DRG NO.: 410 04

DRAWING: QA BRICK ELEVATIONS

BLOOR HOMES.

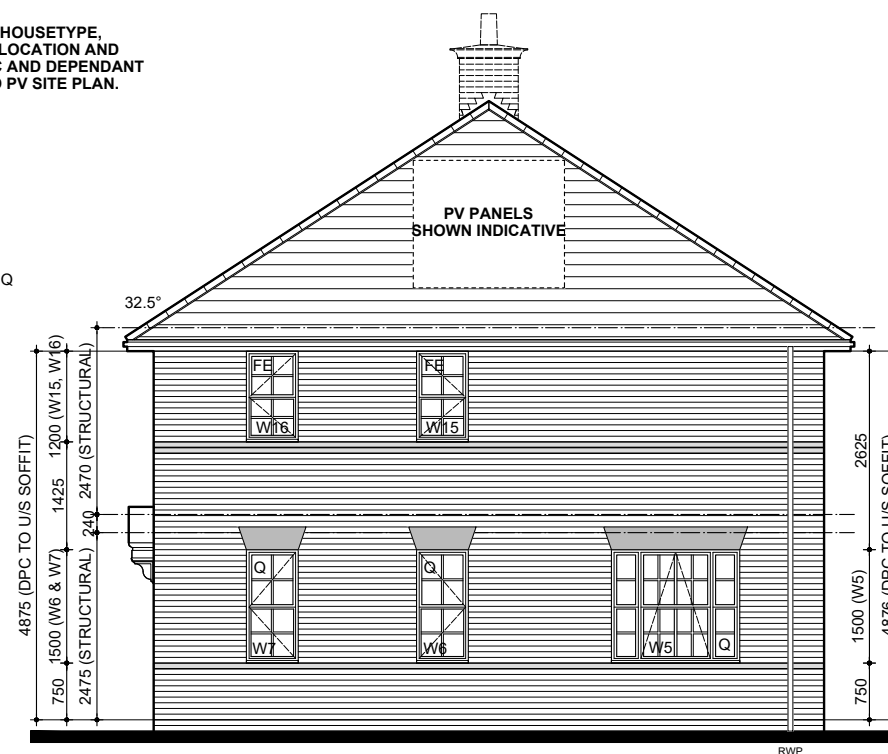
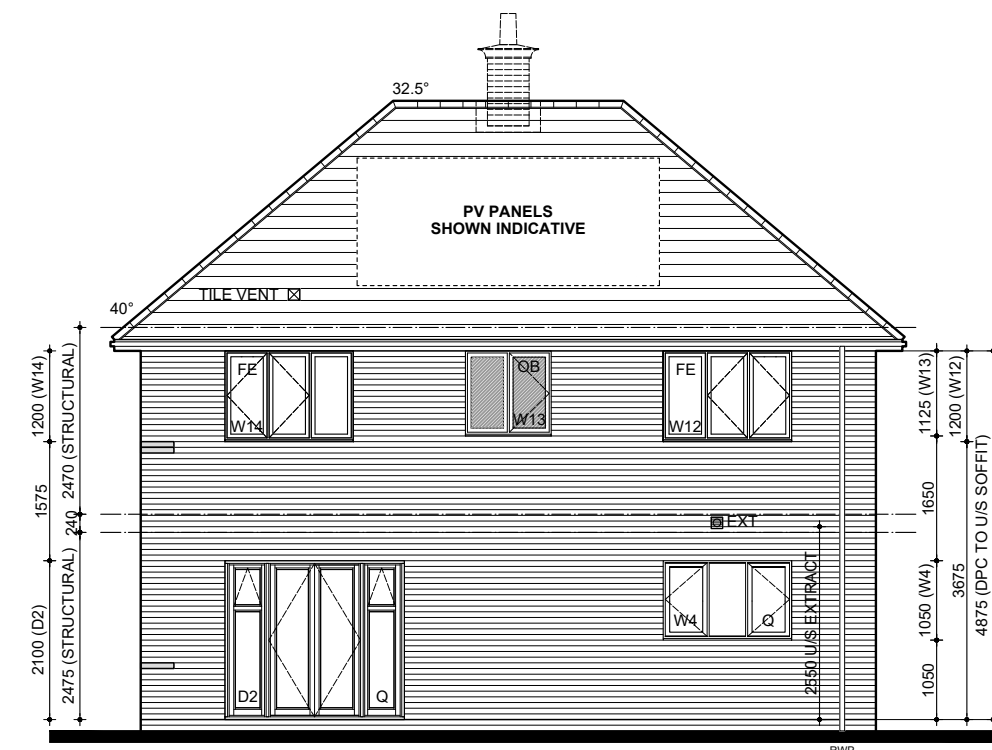
EXTRACT LOCATIONS REVISED TO SUIT NEW FAN LOCATIONS; BED 2 EN-SUITE EXTRACT FAN POSITION REVISED TO CEILING MOUNTED IN LINE WITH FEEDBACK. SVP VENT TILE AMENDED. CHECK REVEAL DIMENSIONS ADDED TO ELEVATIONS.
